Contract #: 04-0120F4Cty: SF/ALA Rte: 80 PM: 13.2/13.9File #: 69.25B

QUALITY ASSURANCE -- NON-CONFORMANCE REPORT

Reference Description: Missed UT indications discovered by QA for RS Stiffener to Floorbeam connections on Lift 13CW

Job Name: SAS Superstructure

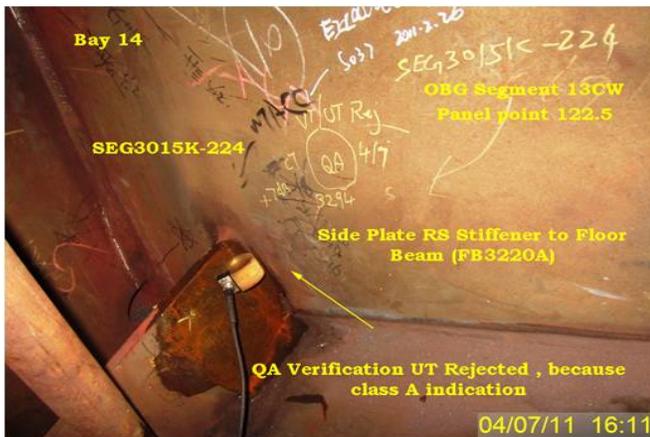
1. The Indication rating is +4dB and length approximately 20mm.

The Thickness of the plate is 22mm and depth of the indication approximately 16mm.

The indication is located on the weld joint identified as SEG3015H-276.

The "Y" location for this indication is approximately 145mm from top edge of this RS Stiffener.

The weld is a Complete Joint Penetration (CJP) "T" weld joint joining Side Plate RS Stiffener to Floor Beam (FB3224A) at panel point 123.

This weld did not meet the Visual Testing (VT) requirements of the contract documents due to incomplete welding at the cope hole.

2. The Indication rating is +7dB and length approximately 25mm.

The Thickness of the plate is 22mm and depth of the indication approximately 19mm.

The indication is located on the weld joint identified as SEG3015K-224.

The "Y" location for this indication is approximately 35mm from top edge of this RS Stiffener.

The weld is a Complete Joint Penetration (CJP) "T" weld joint joining Side Plate RS Stiffener to Floor Beam (FB3220A) at panel point 122.5.

This weld did not meet the Visual Testing (VT) requirements of the contract documents due to visible slag and

Reference Resolution: ZPMC has repaired the indications noted in the NCR and providing WR & NDT documentation after the repair to show the indication has been removed.

焊缝编号为：SEG3015H-271, SEG3015K-224

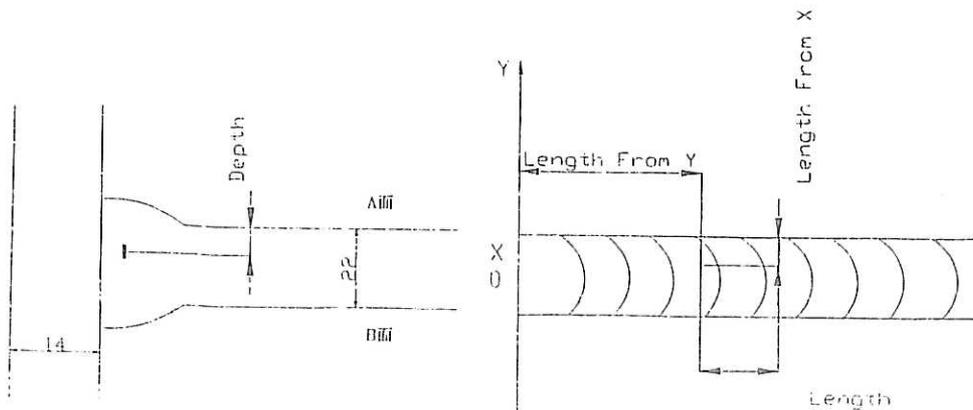
(Description of welding discontinuity): Rejected indication found by ultrasonic inspection is less than the maximum allowance aggregate length.

- 1、焊道未及时处理干净。
1. Did not clear the weld pass completely in time.

1. 从缺陷距离端面较近一侧 ($D \leq 0.65T$, D为缺陷深度, T为板厚) 采用碳刨或打磨的方法去除焊缝缺陷;
 2. 参照返修焊接工艺规程 (WPS) 准备正确的接头型式, 预热和焊接;
 3. 将修补区域打磨到与母材或邻近焊缝平齐;
 4. 根据批准的车间图纸检查焊缝.
-
1. Gouge or grind from nearer side from metal edge ($D \leq 0.65T$, "D" is depth of defects, "T" is thickness of metal) to remove all defects;
 2. Follow repair WPS for joint preparation, preheat, and weld deposit;
 3. Grind the repaired area flush with base metal or the adjacent weld;
 4. Check the welds according to the working drawings.

焊缝编号为: SEG3015H-276, SEG3015K-224

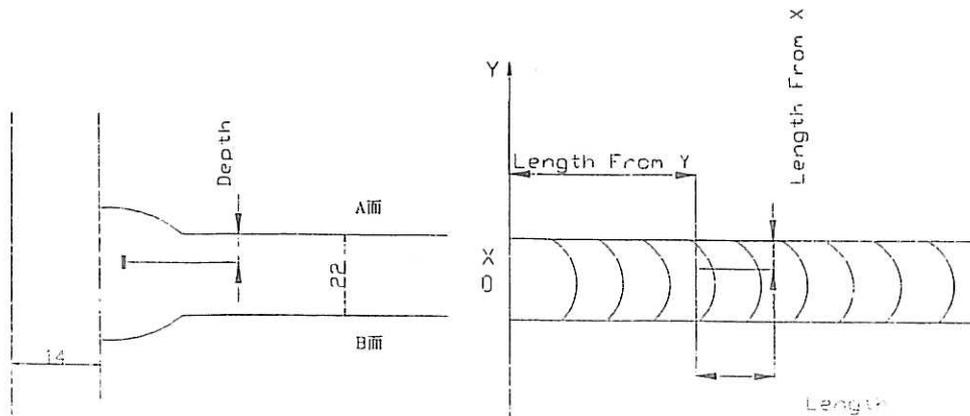
(Description of welding discontinuity): Rejected indication found by ultrasonic inspection is less than the maximum allowance aggregate length.

- 1、焊道未及时处理干净。
1. Did not clear the weld pass completely in time.

1. 从缺陷距离端面较近一侧 ($D \leq 0.65T$, D为缺陷深度, T为板厚) 采用碳刨或打磨的方法去除焊缝缺陷;
2. 参照返修焊接工艺规程 (WPS) 准备正确的接头型式, 预热和焊接;
3. 将修补区域打磨到与母材或邻近焊缝平齐;
4. 根据批准的车间图纸检查焊缝.

1. Gouge or grind from nearer side from metal edge ($D \leq 0.65T$, "D" is depth of defects, "T" is thickness of metal) to remove all defects;
2. Follow repair WPS for joint preparation, preheat, and weld deposit;
3. Grind the repaired area flush with base metal or the adjacent weld;
4. Check the welds according to the working drawings.
